FILE NUMBER: Z190-158(RM) **DATE FILED:** December 6, 2019

LOCATION: Northeast corner of Gulden Lane and Singleton Boulevard

REQUEST: An application for a Planned Development District for office and mixed uses on property zoned an IR Industrial Research District.

STAFF RECOMMENDATION: **Approval**, subject to a revised development plan, a revised streetscape exhibit, and staff's recommended conditions.

APPLICANT'S PROPOSED DEVELOPMENT PLAN

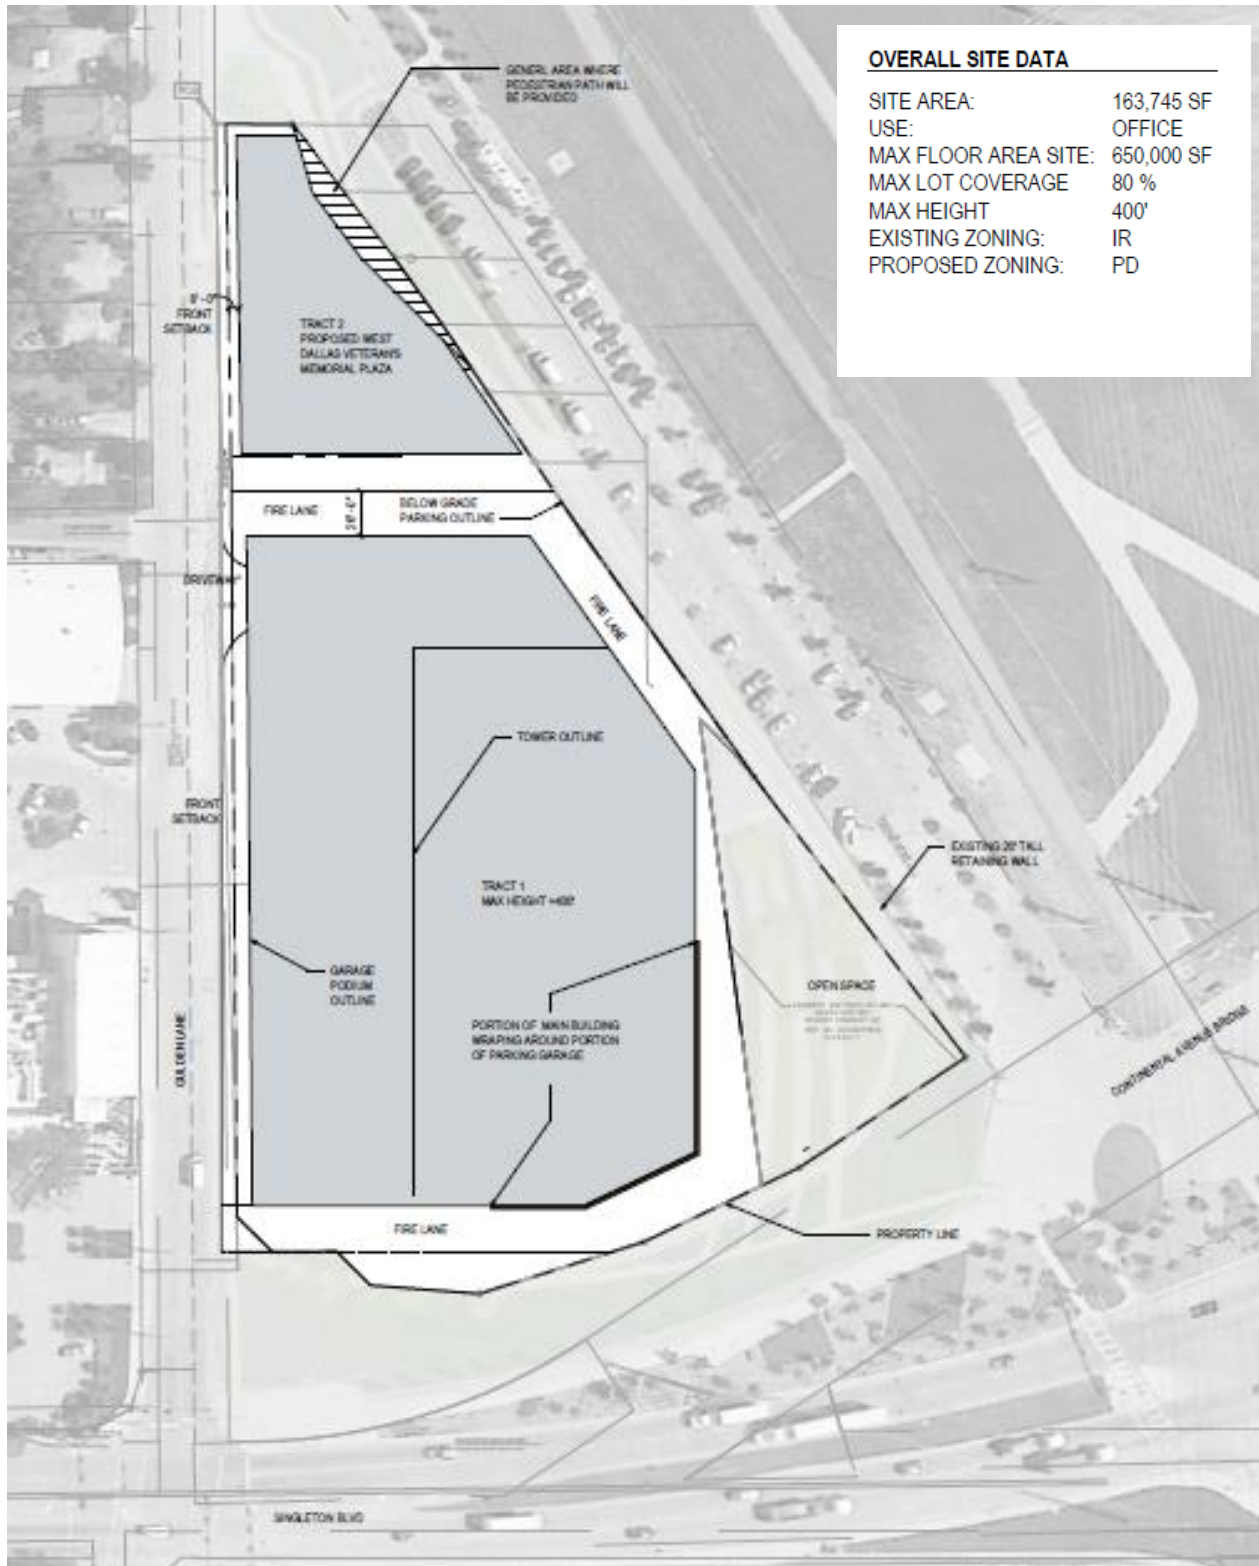
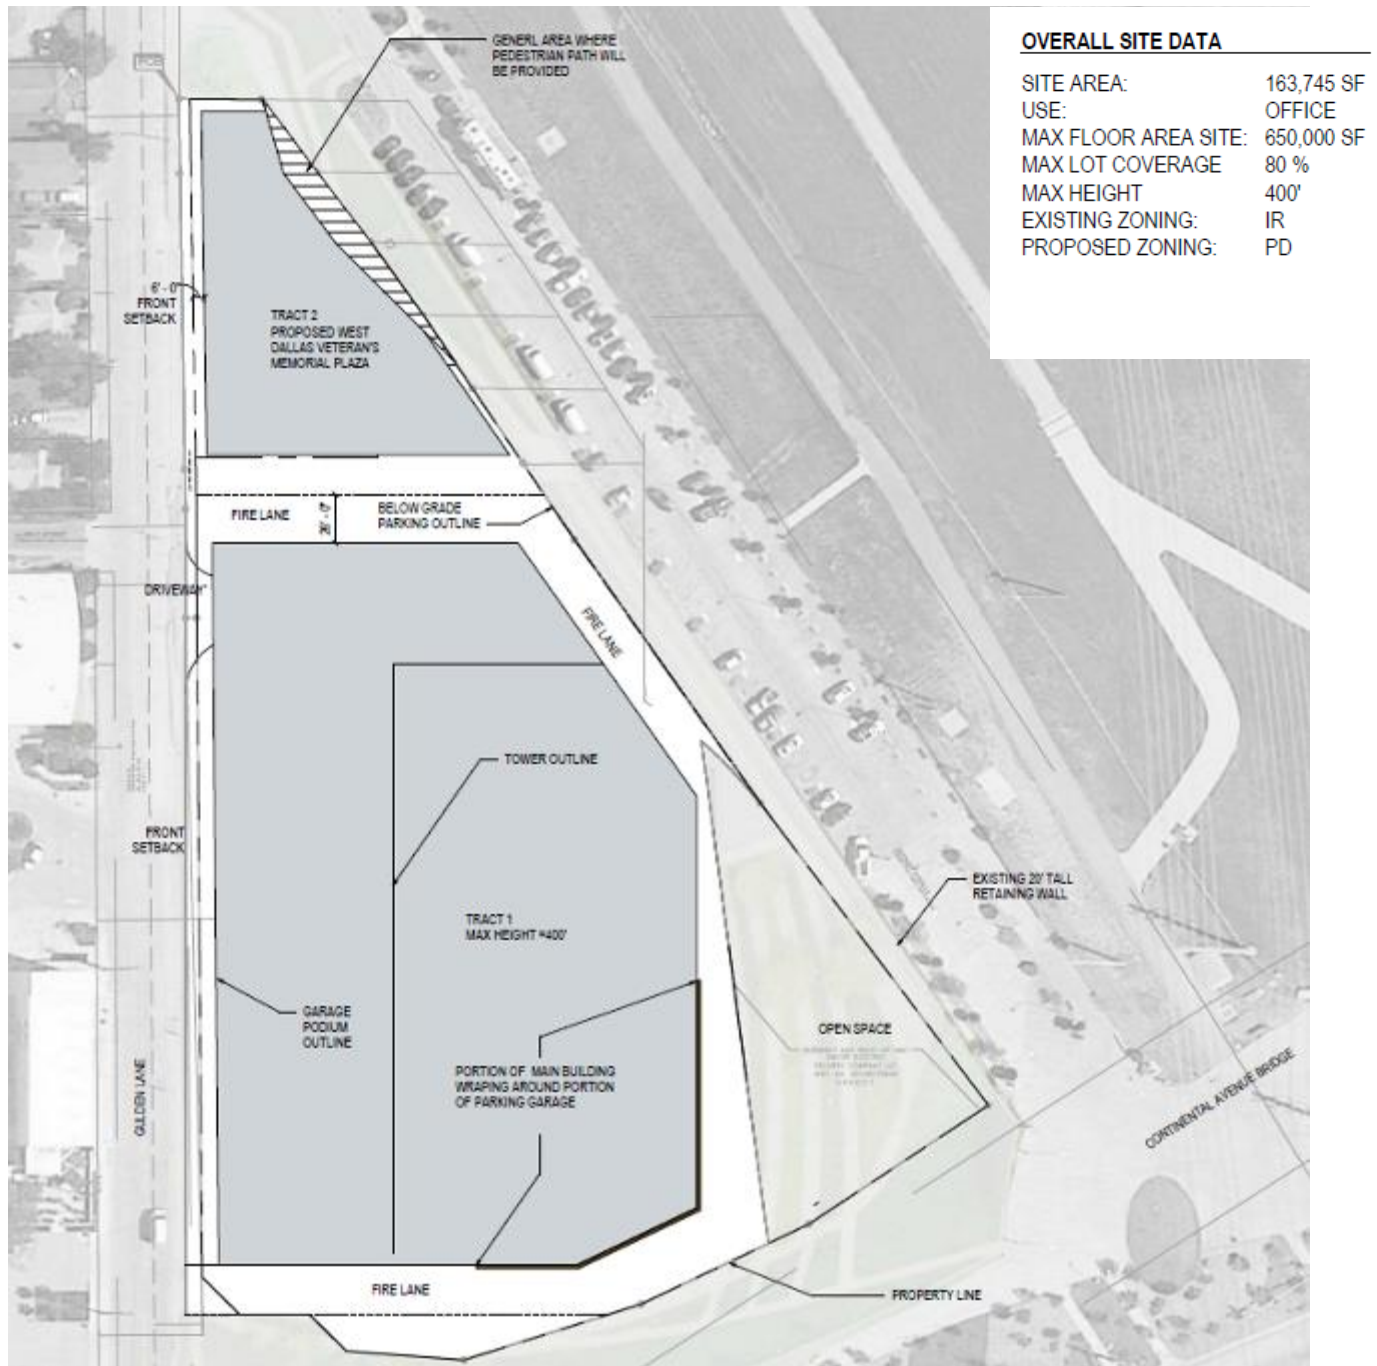
- 10) Allow shared improvements between Tract 1 and Tract 2 consisting of driveways, paved areas, fire lanes, and similar horizontal improvements.
- The proposed development plan has been revised to reflect a wider and longer pedestrian path, an open space area along the southeastern portion of the site, and the conditions have been revised removing the request for district identification signs and roof signs. The City Attorney Office, CAO has outlined concerns with roof tops signs, requested in PDs. As a result of the determination, rooftop signs are now limited to district identification signs, as an alternative. Staff does not support the inclusion of the open space due to the location along a major arterial road and the open space encroaching into a required 26-foot-wide fire land that encircles the development and prevents the open space from containing pedestrian amenities.

- As requested by the Commission, the development plan fails to provide an elevation for the office tower or garage podium and/or a varied height plan (like Z190-180) to better determine how the proposed height would be staggered with the maximum height moving east and away from the residential properties.

Staff does not support the request to allow surface parking on Tract 2. The request has received staff support due to the designation of Tract 2 being allowed only that of an open space or public amenity for the benefit of the community. Building Inspections has similar concerns with the lack of definition that can lend itself to subjective interpretation of “similar horizontal improvements.” While the conditions do not state the intention for surface parking, staff strongly believes that parking is the intention due to the added language of “similar horizontal improvements” that can only be interpreted as surface pavement. If the concern lies with utilizing a shared drive for access or a fire lane, BI has confirmed that the condition, is not needed and strongly discouraged, since a mutual access agreement can be submitted at permitting.

Overall, staff supports the request subject to staff’s recommended conditions as described in this report. However, staff does believe that more consideration should be given to the development of Tract 2 to ensure that the requested increases in development rights are contingent on the development of the public amenity being offered to the community. Staff’s support comes from conservation of the existing La Bajada neighborhood, encouragement of incremental growth, and the creation of a dense east/west center spine focusing development pressure away from the existing neighborhood, as described in The Trinity. Additionally, the request site’s location at a major entry point into West Dallas from downtown, the proximity to the Margaret Hunt Hill Bridge and the Trinity River offers more of a transitional character that can support more height and density with attention to design consideration at the edge of the existing La Bajada neighborhood.

APPLICANT'S PROPOSED STREETSCAPE EXHIBIT

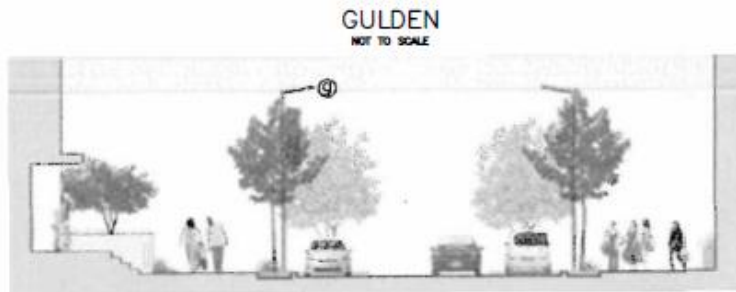
- 6) deviating from the streetscape standards as required by the West Dallas Urban Structure and Guidelines Area Plan (the Structure);
 - 7) allow Tract 1 and Tract 2 to be considered as one lot when calculating the floor area ratio;

The Engineering Division of the Sustainable Development and Construction Department reviewed the request and finds that the deviation from the Complete Streets Manual regarding streetscape standards will not significantly impact the surrounding roadway system.

(2) Gulden Lane tree planting strip. A tree planting strip is required adjacent to the sidewalk along Gulden Lane as shown on the Streetscape Standards (Exhibit ____B).
